Interactive comment on “Sediment yield model implementation based on check dam infill stratigraphy in a semiarid Mediterranean catchment” by G. Bussi et al.

G. Bussi et al.

Received and published: 29 April 2013

Fig. 1. Soil erosion map of the October 2000 event.

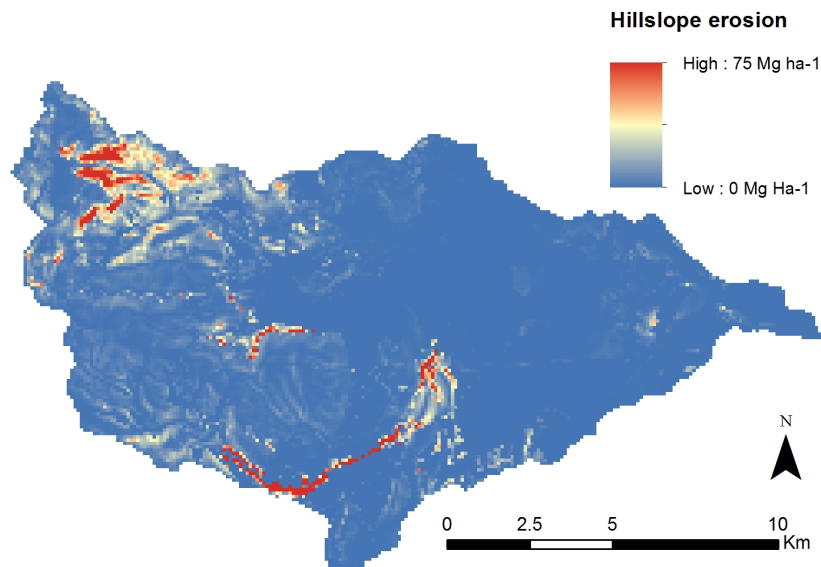
The reviewer states that “A much simpler (lumped) model might provide similar results without the need for such a complex distributed model”. This affirmation may be correct for studies focusing a single catchment. Nevertheless, the aim of this paper was not only to estimate the sediment yield at the check-dam catchment, which, as stated by the reviewer, can be done by using a simpler approach. The additional advantages of a distributed model versus the difficulties of its implementation should be known by the reader. Distributed model results can be extrapolated to the whole domain of study, downstream and upstream the calibration point. In the presented case (Rambla del Poyo catchment). The calibrated and validated model can be used to determine the sediment yield to the floodplain. Furthermore, distributed models can provide state variable values at every cell of the domain of the study. In this case, a map of soil erosion may be produced of the whole Rambla del Poyo catchment, as shown in the attached map for the Rambla del Poyo stream gauge station after the October 2000 (the largest event of the series).

This kind of erosion map cannot be produced using a simple lumped model calibrated at one check-dam.
